ADDENDUM

DATE: April 9, 2014
TO: Commissioners and Interested Parties
FROM: South Central Coast District Staff
SUBJECT: Agenda Item Th18a, Notice of Impending Development (NOID) UCS-NOID-0002-14 –University of California at Santa Barbara (UCSB) Thursday, April 10, 2014

SUBJECT: Notice of Impending Development (NOID) UCS-NOID-0002-14 for the Faculty Club Addition and Renovation Project, for Public Hearing and Commission Action at the April 10, 2014, Commission Meeting in Santa Barbara, CA.

Exhibit 4
Proposed Site Plan
UCSB NOID UCS-NOID 0002-14

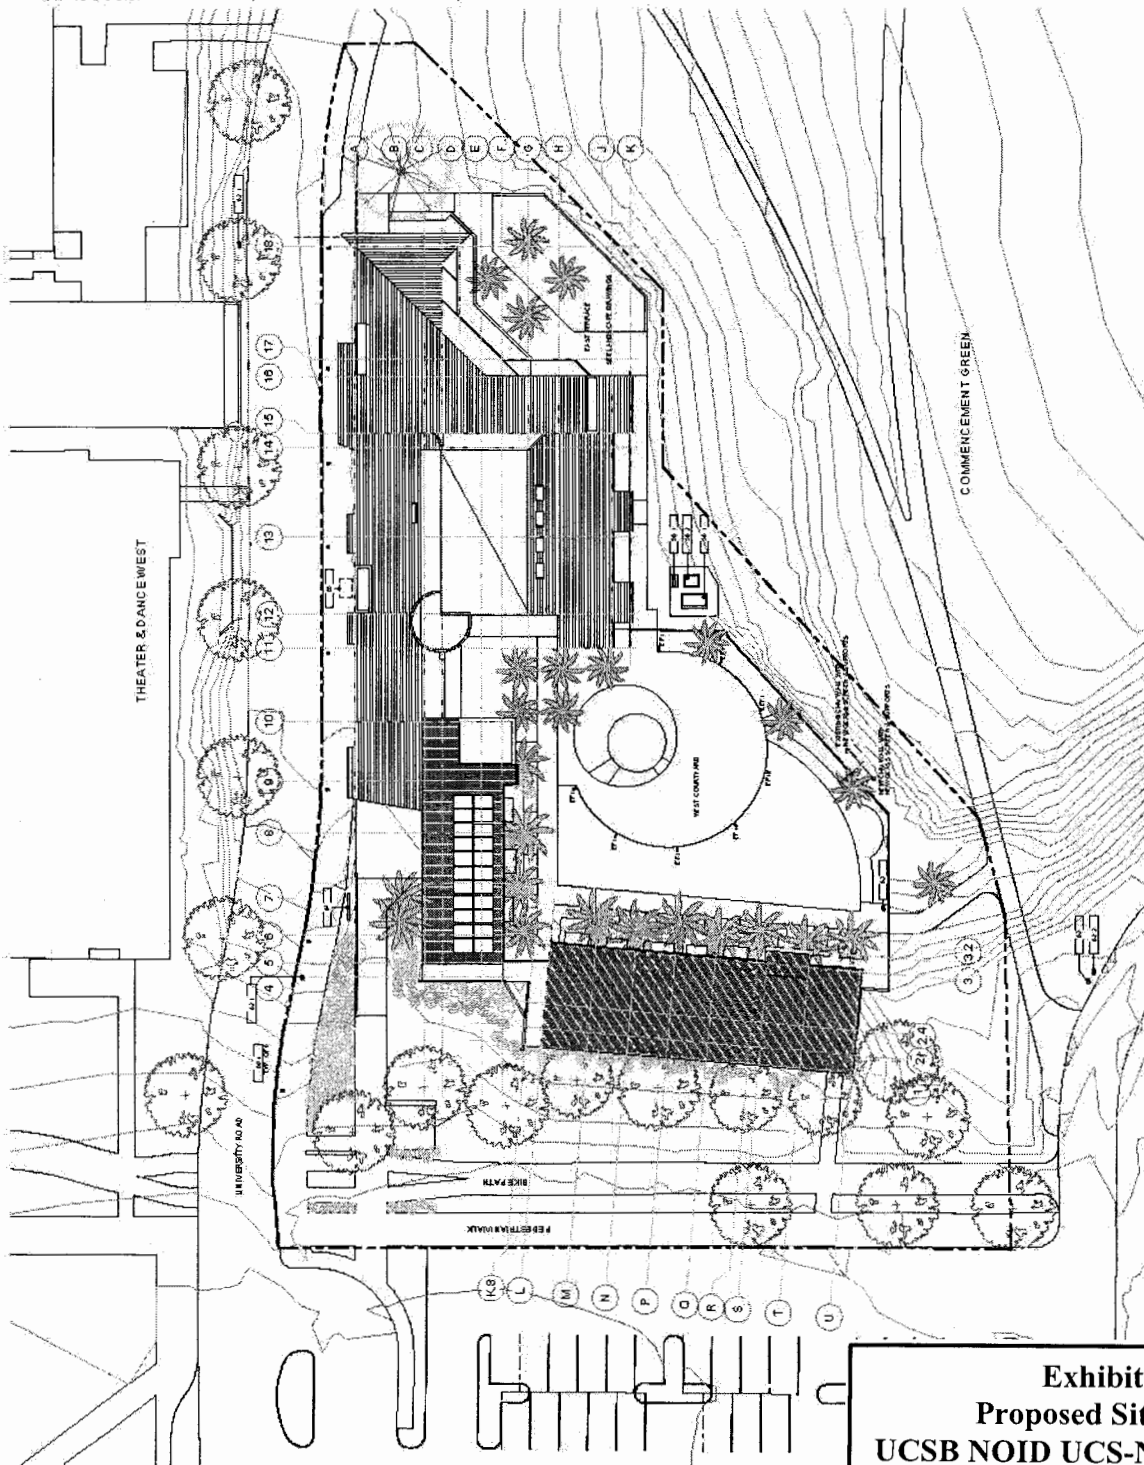
- (a) The lighting plan shall identify the locations of all existing exterior lighting fixtures on the project site within the project boundary, as depicted on Project Plan Sheet A0.10 which is included as Exhibit 4 of the staff report, and within the vicinity of the project site that do not meet the design and efficiency standards set forth in subsection (b) below. (Special Condition 6 (b)).
